SUBJECT: First Five-Year Review Report  
Piper Aircraft Superfund Site  
Vero Beach, Indian River County, Florida

**First Five-Year Review Report for  
PIPER AIRCRAFT NPL SITE  
The New Piper Aircraft, Inc.  
Vero Beach, Indian River County, Florida**

**December 2003**

Thank you for your submittal of the First Five-Year Review Report (DRAFT). EPA and FDEP have reviewed the document and submit the following comments. The Five-Year Review process is intended, in part, to evaluate the protectiveness of the selected remedial action. According to the details in the report, EPA feels that modifications to the remedial action should be considered by Piper because the UVB wells do not appear to be operating properly and adjustments could be made in the location and monitoring of the monitoring wells to improve the systems efficiency. Please view this comment letter in two respects: First, comments on the report itself (listed mostly in Section 1.) should be addressed so the that the report can be finalized and approved by EPA. Second, comments concerning the potential modifications to the remedial action (Sections 2. through 5.) should be considered in any future work at the site. EPA r

**FIGURE 14**

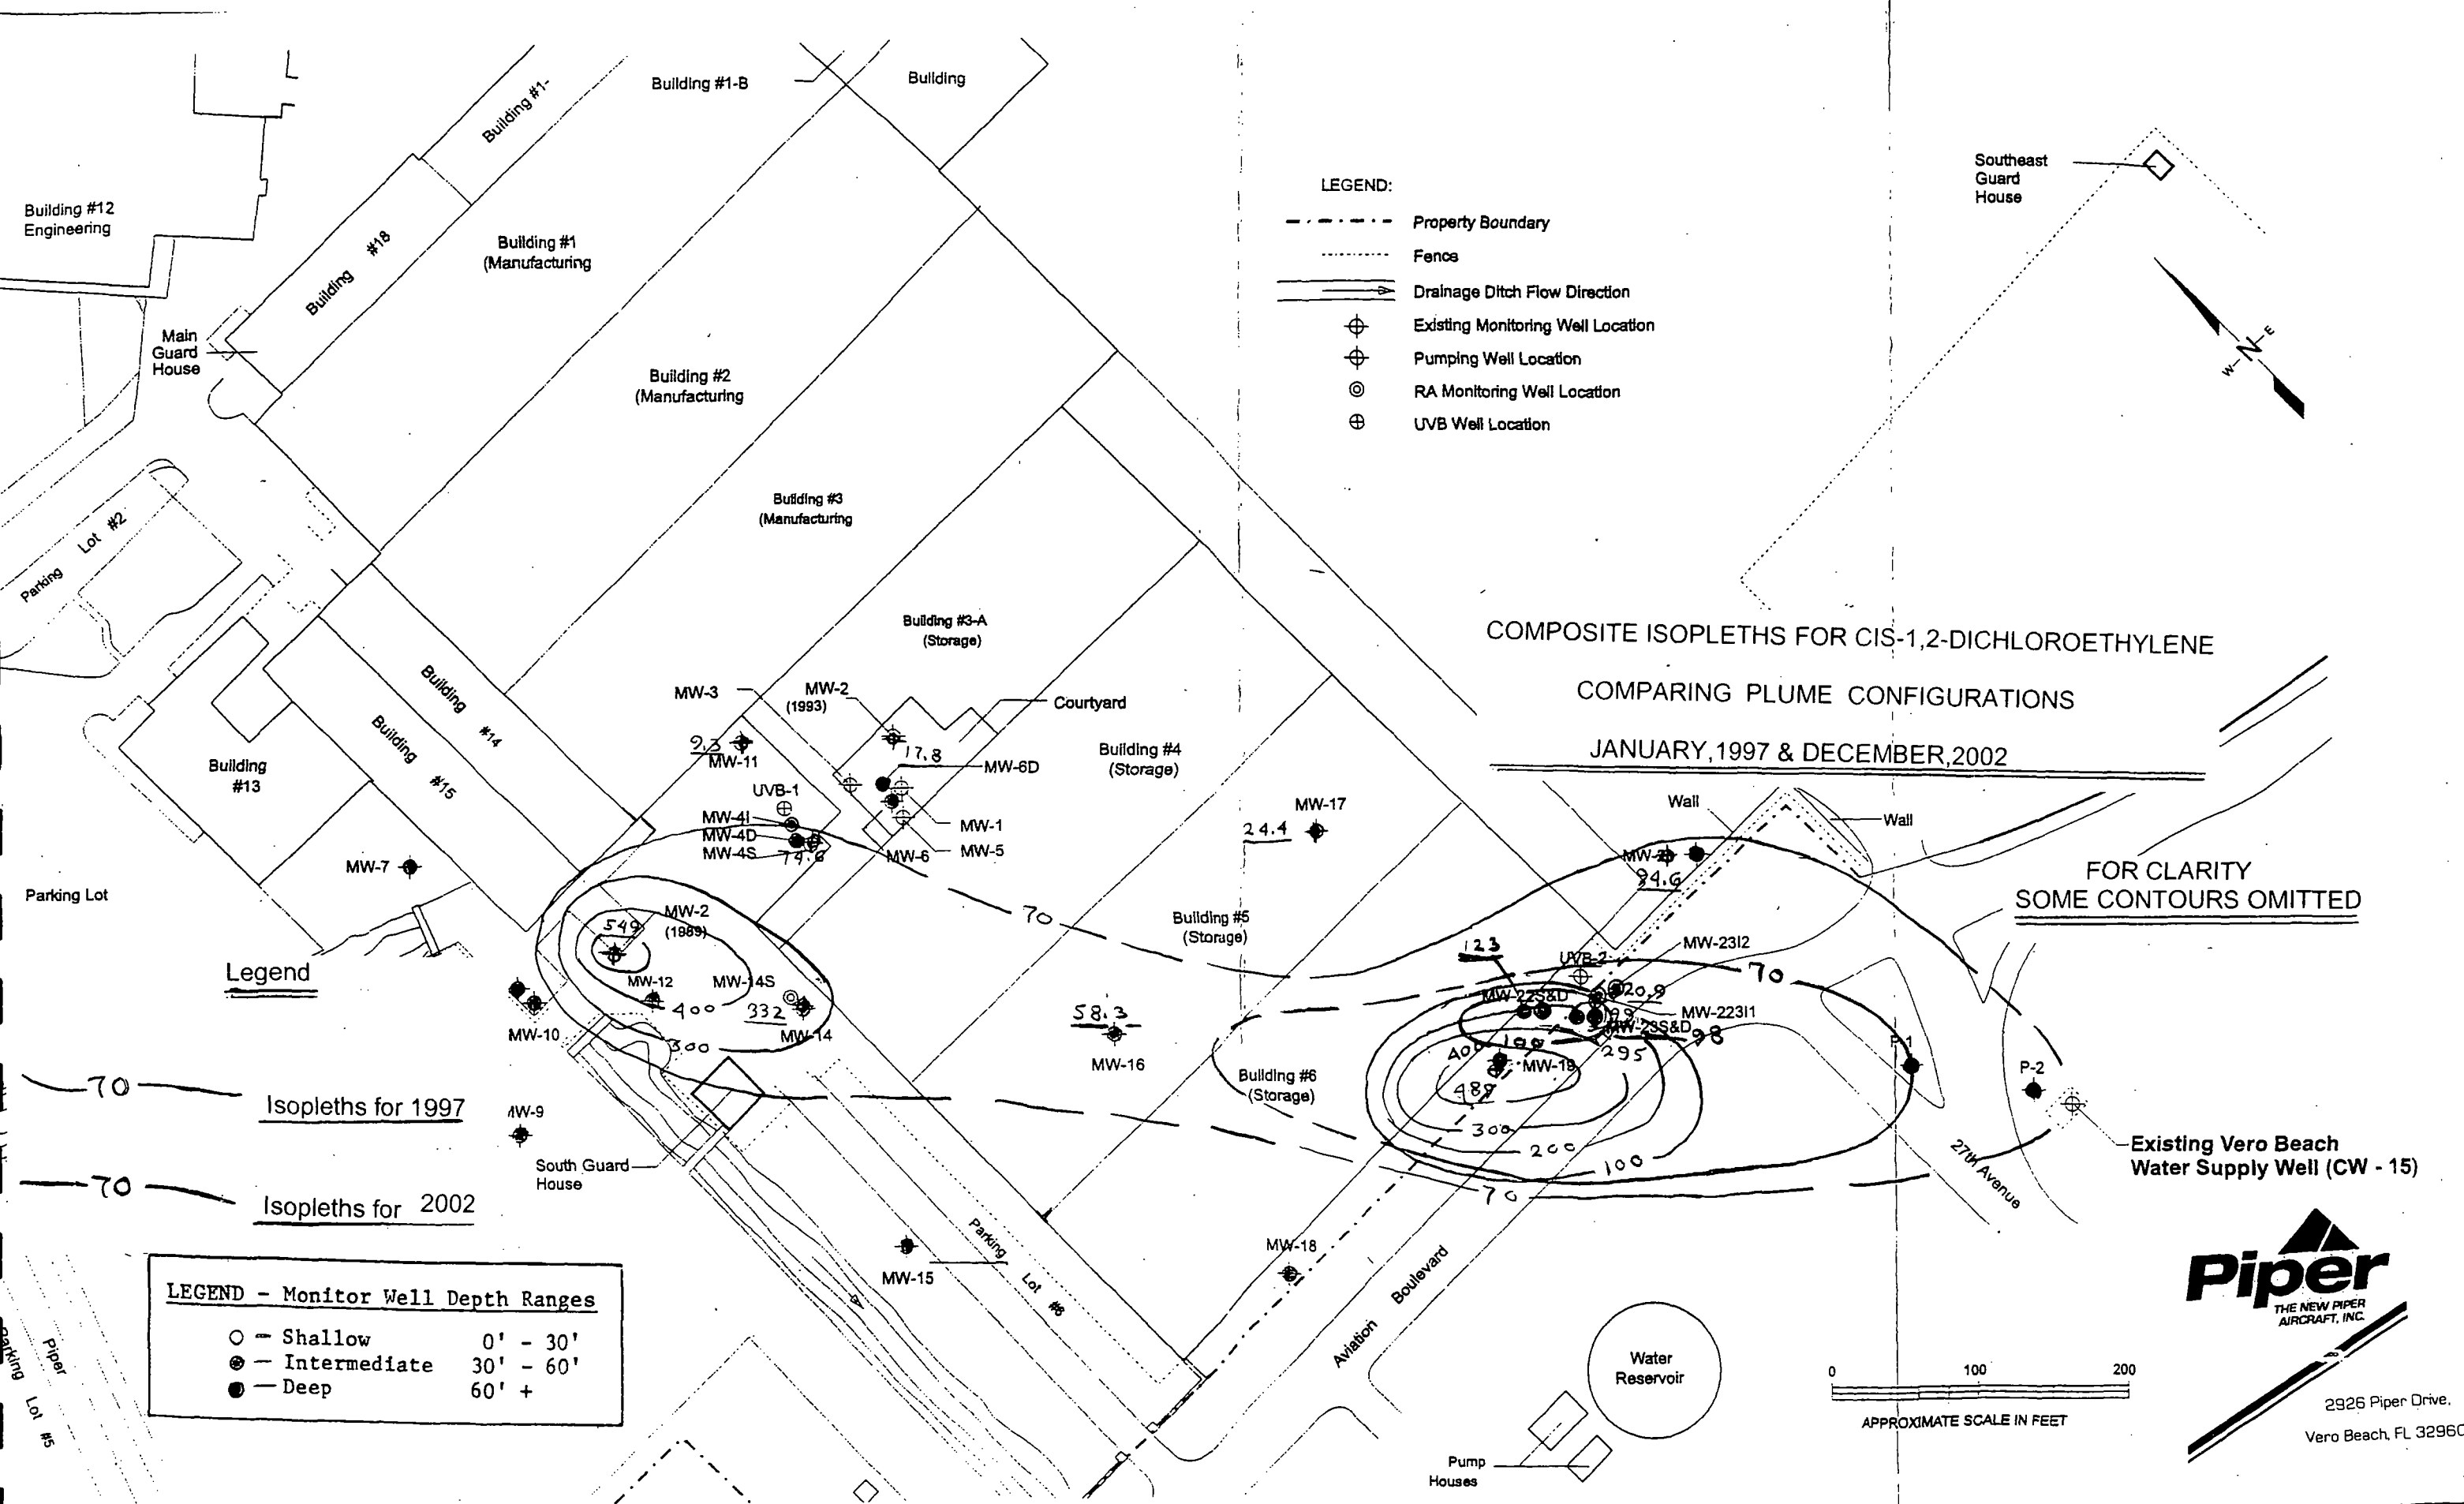
- 1.13 On page 19, the report states that at present, the only interpreted occurrence of cis 1,2-DCE above a 70 ug/L concentration is in the area between monitoring wells MW-19 and MW-23. Based on the December 2002 data, that interpretation is valid. However, data from MW-16 have periodically shown cis 1,2-DCE concentrations above 70 ug/L, most recently the June 2002 sample. It is unclear why the cis 1,2-DCE data from that well should show a great degree of variability, with low (or even nondetect) concentrations alternating with concentrations above the 70 ug/L MCL. Regardless of the cause, these periodic excursions of cis 1,2-DCE above 70 ug/L at MW-16 suggest there may be some significant cis 1,2-DCE contamination between that monitoring location and MW-19, or somewhat further upgradient than the 70 ug/L contour for December 2002 that is shown on Figure 15. The report text on page 19 should acknowledge there may be some more significant cis 1,2-DCE contamination for some distance upgradient of MW-19 that is not identified because of the absence of any monitoring wells between MW-16 and MW-19, or at the MW-16 location but deeper in the aquifer (note that Figure 8 suggests that more significant contamination is present around MW-16 but deeper than the screened interval for that well). FDEP made this same comment.

*Figure 15 isopleths show a decrease in cis,-1, 2 DCE from 1997 through 2002 in the area of MW-19. Isopleths are somewhat misleading in that they depict a smooth transition and connected occurrence of contamination. The residual contaminants probably occur in a three-dimensional random arrangement of small lenses and blobs, the placement of which is controlled by an interplay of hydrologic, geologic and phase relationship variables. Looking for a progressive downward trend in certain wells can be unproductive. The ups and downs in residual concentration shown by various wells despite a rigorous attempt to keep all sampling protocols identical are attributed to the sporadic and intermittent release of contaminants to the down gradient water flow occurring in a fairly anisotropic aquifer.*

Figure 16  
VINYL CHLORIDE ISOPLETHS  
JAN. 1997 and DEC. 2002

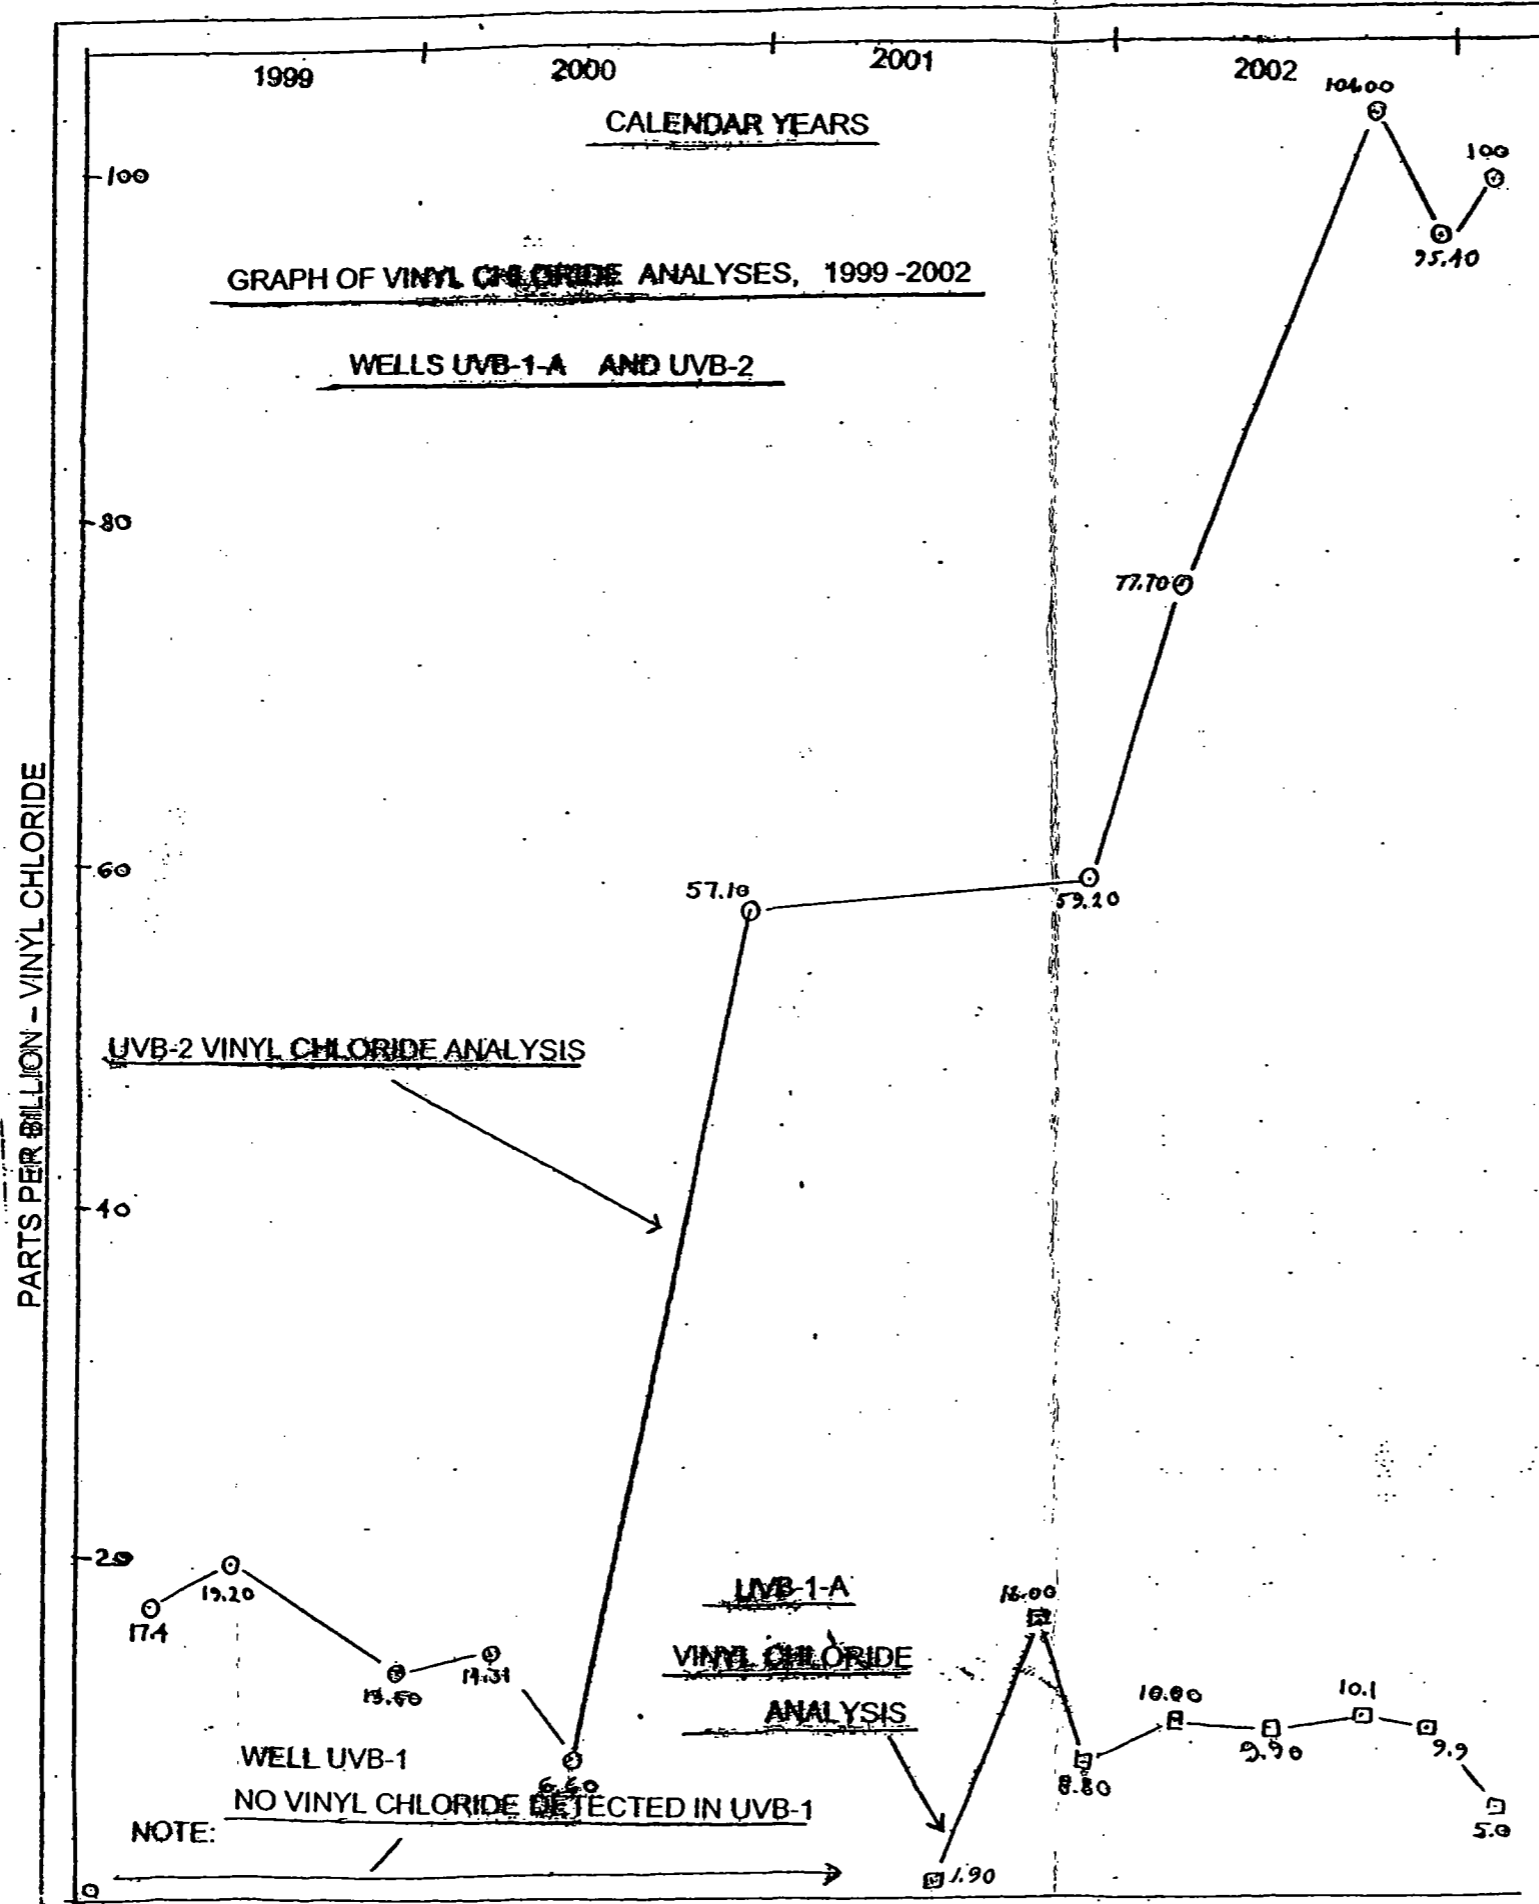
5.2 In the downgradient plume area, there are two concerns. First, the plume configuration in the area around UVB-2 may not be fully understood, based on the depiction of the vinyl chloride contamination in the Five-Year Review Report Figure 8 cross section. This figure suggests there is a relatively concentrated part of the plume at a depth of roughly 20 to 30 feet, and a second area of relatively high concentrations (in at least a part of the plume) at a depth of roughly 60 feet. There needs to be some better confirmation of the vertical distribution of contaminants and the depth of the most significant contamination in this area. This information can then be used to establish the most appropriate locations and depths for monitoring the progress of further remedial actions in the mid-plume area.

WELL UVB-2  
 FIVE YEAR OPERATIONAL HISTORY  
 FIGURE 19

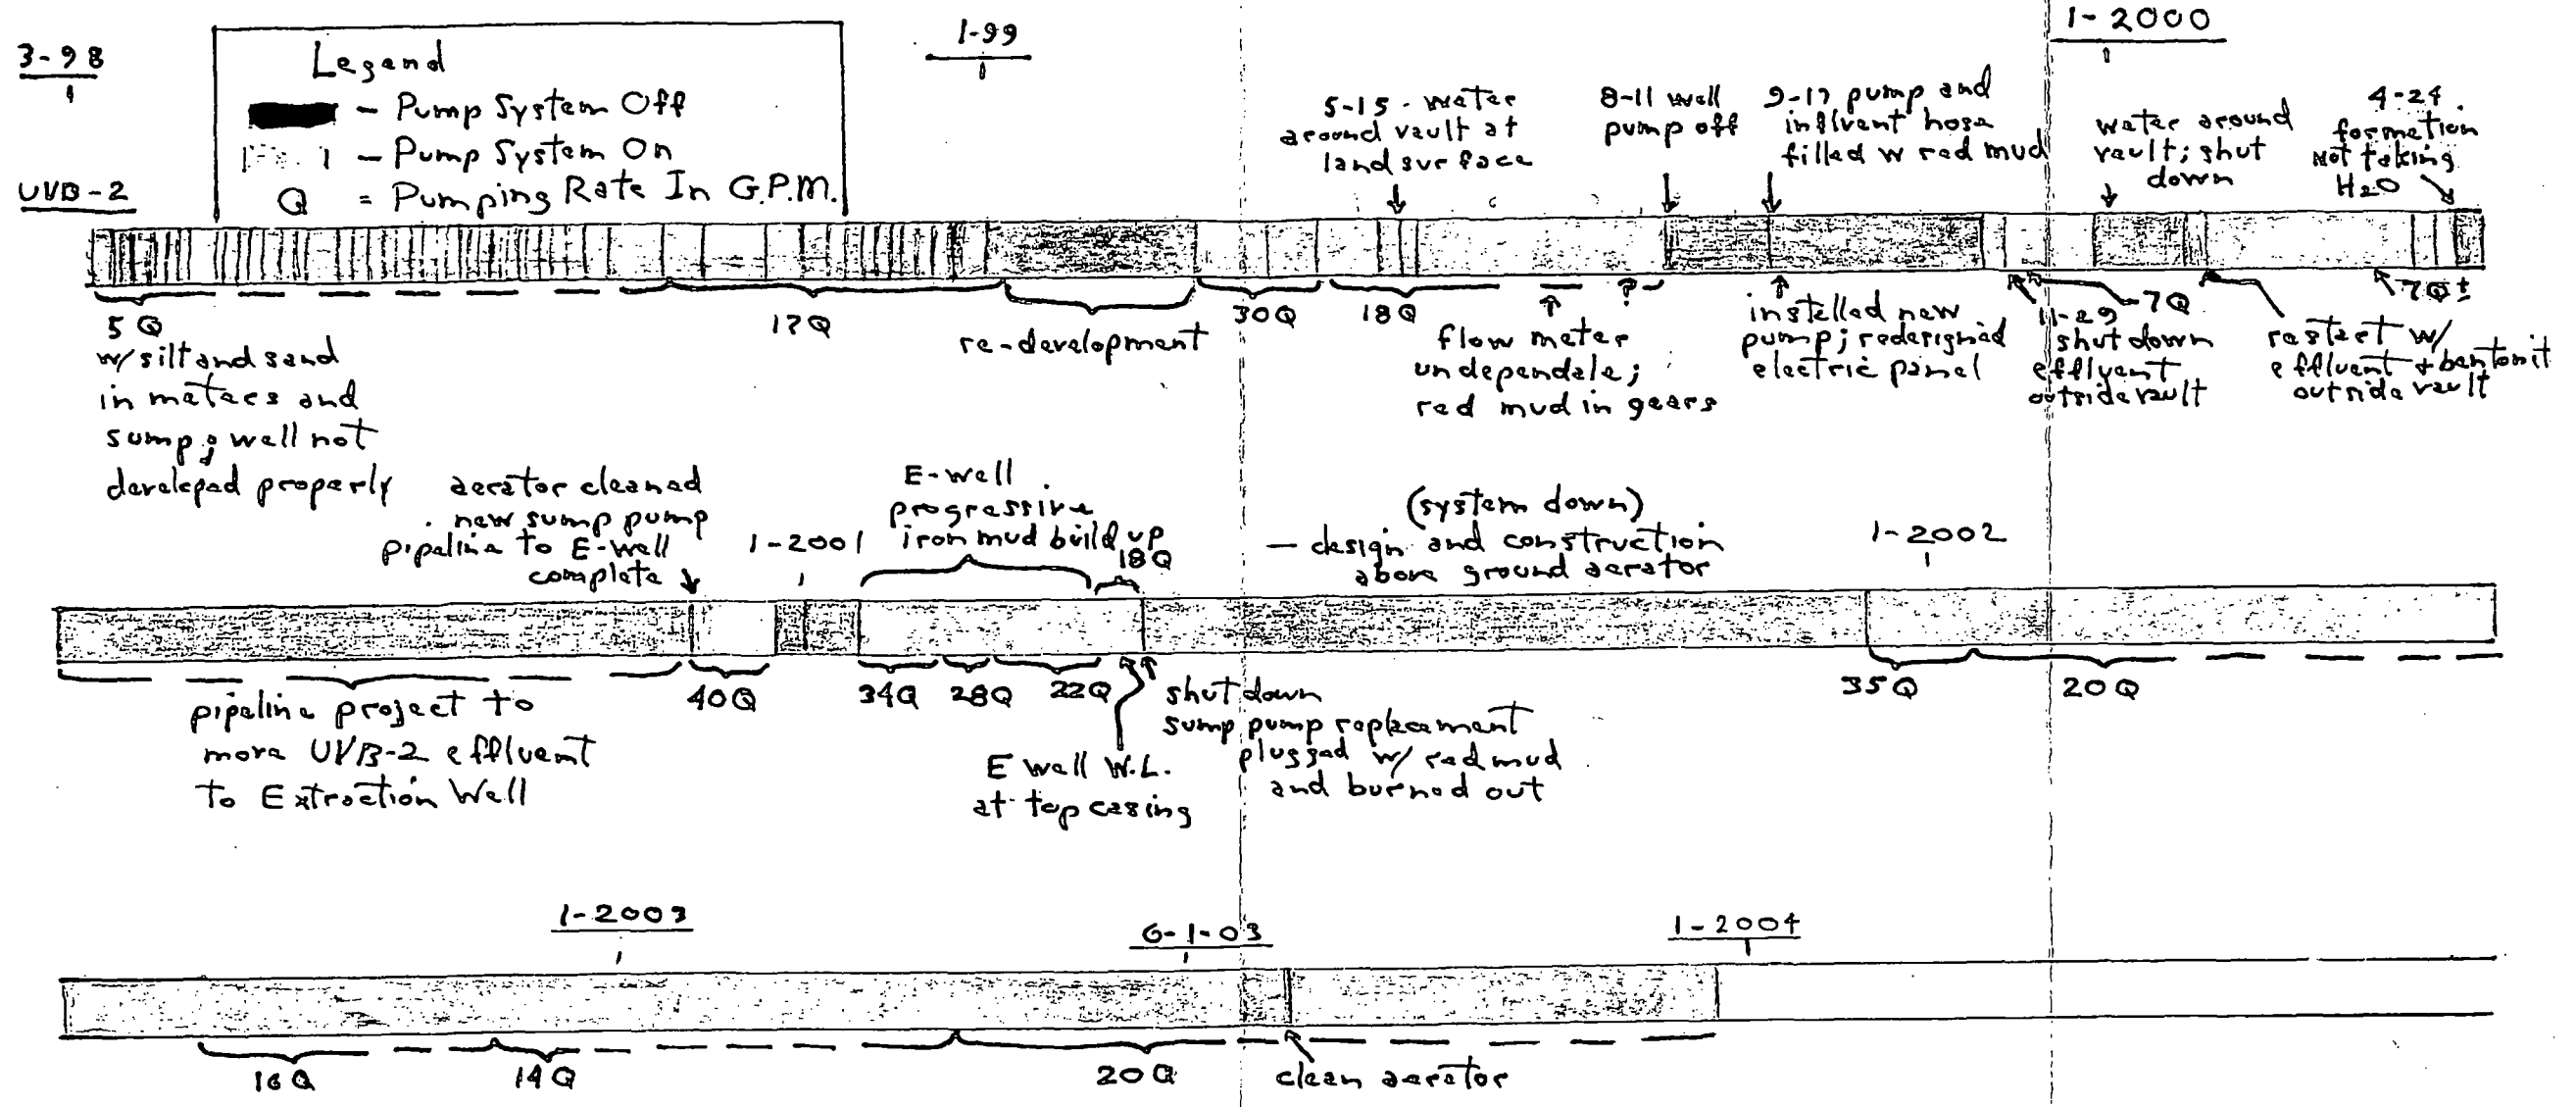
- 1.9 A summary is needed in this Five-Year Review Report of the periods when well rehabilitation was performed on the UVB well(s). This summary would describe conditions leading to each well rehabilitation, the dates of those rehabilitation periods, the geochemical environments (if known) that are responsible for the differing responses noted at UVB-1 and UVB-2 (reference the last paragraph of Section in. 5. on page 14; the statement indicates that only UVB-1 has been redeveloped; however, the discussion on page 17 indicates that UVB-2 has also been redeveloped), and the response of the UVB well(s) to each redevelopment (i.e. the noted changes in pumping rate and/or specific capacity, with actual values presented).

Figures 18 & 19 present an operational history of the two UVB wells highlighting significant reasons for system shutdowns including dates of periods to remove red mud from screen sections. The conditions leading to each well development and aerator cleaning were characterized by gradual loss of effluent flow which the receptor wells could accept without overflowing at land surface.
